Comments on “Development of Cross-Polar Orientation-Insensitive Chipless RFID Tags”

O. Rance, N. Barbot, E. Perret

O. Rance, N. Barbot, E. Perret. Comments on “Development of Cross-Polar Orientation-Insensitive Chipless RFID Tags”. IEEE Transactions on Antennas and Propagation, 2022, 70 (5), pp.3922-3923. 10.1109/TAP.2021.3133661 . hal-04047186

Fig. 1. Angular coverage of the individual dipoles and of the total unit cell. This figure should be compared with [1, Fig. 3] which uses scalar summation.

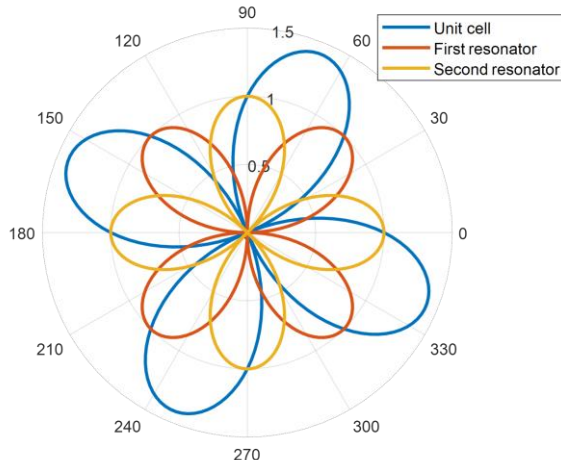
The methodology introduced by the authors to design cross-polar orientation-insensitive chipless tags is illustrated in [1, Fig. 3]. Two dipoles type scatterers oriented respectively at 0° (\mathbf{S}_1) and 45° (\mathbf{S}_2) are combined in order to improve the angular coverage of the total unit cell. The scattering matrix of the total target is given using superposition principle by:

$$\mathbf{S}(0) = \mathbf{S}_1(0) + \mathbf{S}_2(0) = A \cdot \begin{bmatrix} 1 & 0 \\ 0 & 0 \end{bmatrix} + A/2 \cdot \begin{bmatrix} 1 & 1 \\ 1 & 1 \end{bmatrix} \quad (4)$$

Using (3), this gives:

$$S_{vh}(\theta) = A/\sqrt{2} \cdot \cos(2\theta + \pi/4) \quad (5)$$

which appears to be zero for $\theta = 22.5^\circ$ [90°]. The graphical representation of $S_{vh}(\theta)$ normalized by A has been plotted in Fig. 1 for comparison with [1, Fig. 3]. The curves are identical for the first and the second resonators but the unit cell exhibits four nulls contrary to the scalar summation presented in [1]. Therefore, the unit cell shows no improvement in terms of angular coverage compared to the individual dipoles.
